Access Compliance Report

Public Rights-of-Way

Intersection ID: 44487	Main Street: REAMES_RD	Cross Street: FINN_HALL_AV	Location: W
ADA ID: 9F987BCC9EDB	Ramp Type: Perp	Initial Pass/Fail: Fail	Overall Compliance: No
			Severity Score: 21.25

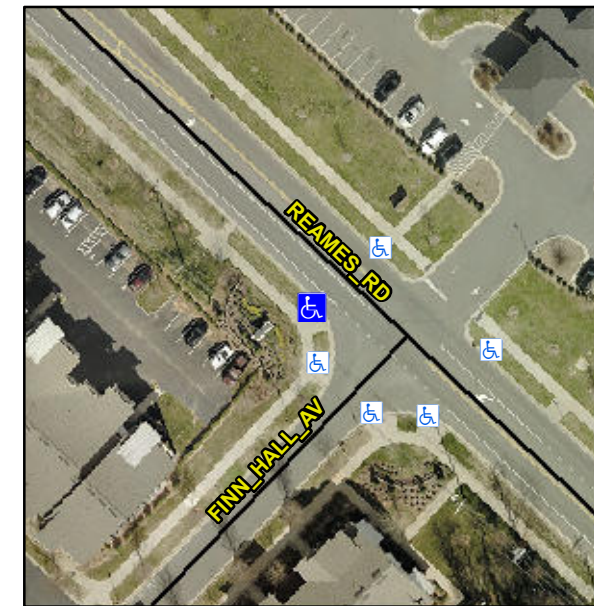
Not Found, R304.5.1, R304.5.3

Compliance	Description	Data	Compliance	Description	Data
N/A	Ramp Length (in)	96.0	Yes	Ramp Slope (%)	7.9
No	Ramp Width (in)	44.0	No	Ramp XSlope (%)	5.1
N/A	Flare Type LT	N/A	N/A	Flare Type RT	N/A
N/A	Flare Slope LT (%)	N/A	N/A	Flare Slope RT (%)	N/A
N/A	Flare Traversable LT?	N/A	N/A	Flare Traversable RT?	N/A
N/A	Landing Length (in)	N/A	N/A	DWS Provided?	N/A
N/A	Landing Width (in)	N/A	N/A	DWS Contrast?	N/A
N/A	Landing Slope (%)	N/A	N/A	DWS Length (in)	N/A
N/A	Landing X Slope (%)	N/A	N/A	DWS Full Width?	N/A
N/A	Landing Curb? (Y/N)	N/A	N/A	DWS Offset (in)	N/A
N/A	Shared Landing?	N/A			
N/A	Gutter Ponding?	N/A	N/A	Gutter Slope (%)	N/A
N/A	Gutter Lip Ht (in)	N/A	N/A	Gutter X Slope (%)	N/A
N/A	Painted X Walk1?	No	N/A	Painted X Walk2?	N/A
	X Walk 1 Direction	To N		X Walk 2 Direction	N/A
N/A	X Walk 1 Width (in)	N/A	N/A	X Walk 2 Width (in)	N/A
	X Walk 1 Slope (%)	7.3		X Walk 2 Slope (%)	N/A
	X Walk 1 X Slope (%)	5.0		X Walk 2 X Slope (%)	N/A

Remove & Replace Entire Ramp.
